Proposal to draft amendments to Regulations No. 3, 27, 69, 70, 104 and 48

Note: The text reproduced below was prepared by the experts from the Czech Republic and CLEPA in order to introduce into the above-mentioned Regulations collective amendments regarding colour specifications for the retro reflective and fluorescent materials specified in the Regulations in question.

B - Proposal to draft amendments to Regulation No. 48

White	Yellow	Amber	Red
-------	--------	-------	-----

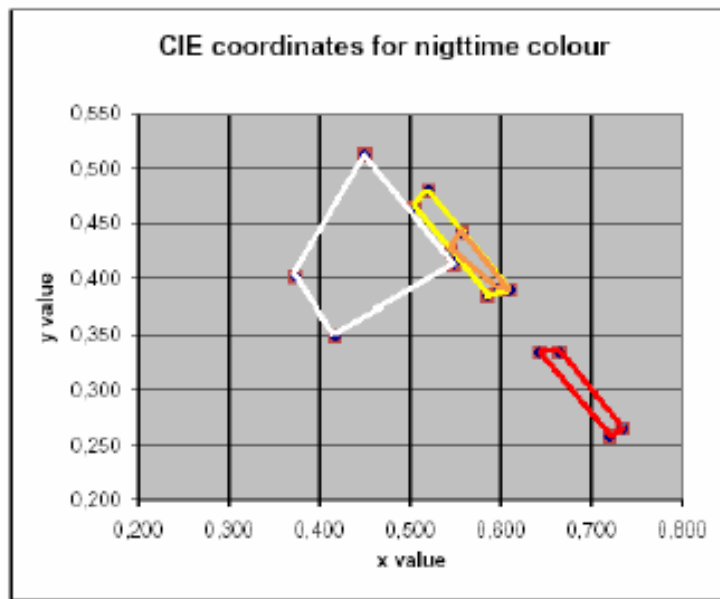
This proposal amends the individual Regulations in question and introduces paragraphs 2.29. for nighttime visibility conditions, 2.30. for daytime conditions of standard colours and 2.31. for daytime conditions of the fluorescent colours.

The drawings bellow represent the final colorimetric coordinates for both conditions as defined in this document.

"2.29. Nighttime Colour of the light reflected from a device

2.29.1. "White" means the chromaticity coordinates (x,y) ^{4/} of the light reflected that lie inside the chromaticity areas defined by the boundaries:

W ₁₂	Blue Boundary:	$y=0.843 - 1.182x$
W ₂₃	Violet Boundary:	$y=0.489x + 0.146$
W ₃₄	Yellow Boundary:	$y=0.968 - 1.010x$
W ₄₁	Green Boundary:	$y=1.442x - 0.136$

x	y
W1	0.373	0.402
W2	0.417	0.350
W3	0.548	0.414
W4	0.450	0.513

2.29.2. "Yellow" means the chromaticity coordinates (x,y) ^{4/} of the light reflected that lie inside the chromaticity areas defined by the boundaries:

Y ₁₂	Green Boundary:	$y=x - 0.040$
Y ₂₃	The Spectral Locus	
Y ₃₄	Red Boundary:	$y=0.20x + 0.268$
Y ₄₁	White Boundary:	$y=0.970 - x$

Y_1	0.505	0.465
Y_2	0.520	0.480
Y_3	0.610	0.390
Y_4	0.585	0.385

2.29.3. "Amber" means the chromaticity coordinates (x,y) of the light reflected that lie inside the chromaticity areas defined by the boundaries:

A_{12}	Green Boundary:	$y=1.417x - 0.347$
A_{23}	The Spectral Locus	
A_{34}	Red Boundary:	$y=0.390$
A_{41}	White Boundary:	$y=0.790 - 0.670x$

x	y
A_1	0.545	0.425
A_2	0.557	0.442
A_3	0.609	0.390
A_4	0.597	0.390

2.29.4. "Red" means the chromaticity coordinates (x,y) of the light reflected that lie inside the chromaticity areas defined by the boundaries:

R_{12}	Yellow Boundary:	$y=0.335$
R_{23}	The Spectral Locus	
R_{34}	The Purple Line	
R_{41}	Purple Boundary:	$y=x + 0.978$

x	y
R ₁	0.643	0.335
R ₂	0.665	0.335
R ₃	0.735	0.265
R ₄	0.720	0.258
